# Access Compliance Report

## Public Rights-of-Way

### (Curb Ramps)

Intersection ID: 10033070	Main Street: NORTH_COMMUNITY_HOUSE_RD	Cross Street: N/A	Location: NE
ADA ID: 04CCD3B6EA91	Ramp Type: Perp	Initial Pass/Fail: Fail	Overall Compliance: No
Severity Score: 21.25			
Codes/Mitigation Info/Possible Solution		Field Measurements/Component Compliance

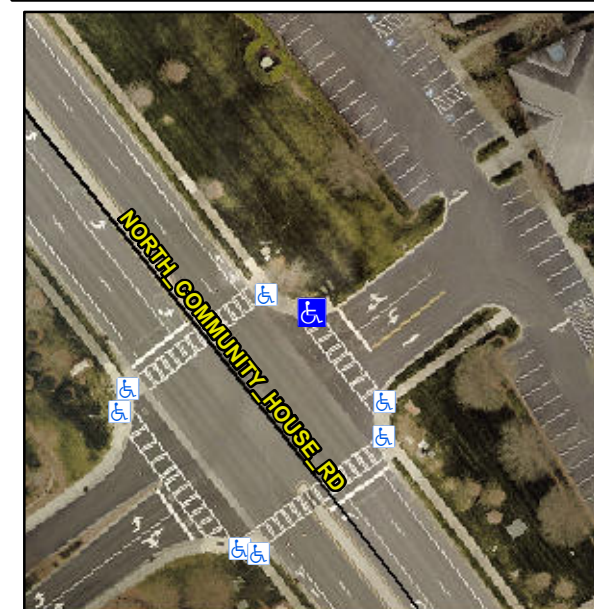
**Not Found, R304.5.1, R304.5.3**

Compliance	Description	Data	Compliance	Description	Data
N/A	Ramp Length (in)	25.5	Yes	Ramp Slope (%)	6.4
No	Ramp Width (in)	47.5	No	Ramp XSlope (%)	5.7
N/A	Flare Type LT	N/A	N/A	Flare Type RT	N/A
N/A	Flare Slope LT (%)	N/A	N/A	Flare Slope RT (%)	N/A
N/A	Flare Traversable LT?	N/A	N/A	Flare Traversable RT?	N/A
N/A	Landing Length (in)	N/A	N/A	DWS Provided?	N/A
N/A	Landing Width (in)	N/A	N/A	DWS Contrast?	N/A
N/A	Landing Slope (%)	N/A	N/A	DWS Length (in)	N/A
N/A	Landing X Slope (%)	N/A	N/A	DWS Full Width?	N/A
N/A	Landing Curb? (Y/N)	N/A	N/A	DWS Offset (in)	N/A
N/A	Shared Landing?	N/A			
N/A	Gutter Ponding?	N/A	N/A	Gutter Slope (%)	N/A
N/A	Gutter Lip Ht (in)	N/A	N/A	Gutter X Slope (%)	N/A
N/A	Painted X Walk1?	Yes	N/A	Painted X Walk2?	N/A
	X Walk 1 Direction	To SE		X Walk 2 Direction	N/A
N/A	X Walk 1 Width (in)	112.0	N/A	X Walk 2 Width (in)	N/A
	X Walk 1 Slope (%)	2.1		X Walk 2 Slope (%)	N/A
	X Walk 1 X Slope (%)	3.7		X Walk 2 X Slope (%)	N/A

**Remove & Replace Entire Ramp.**
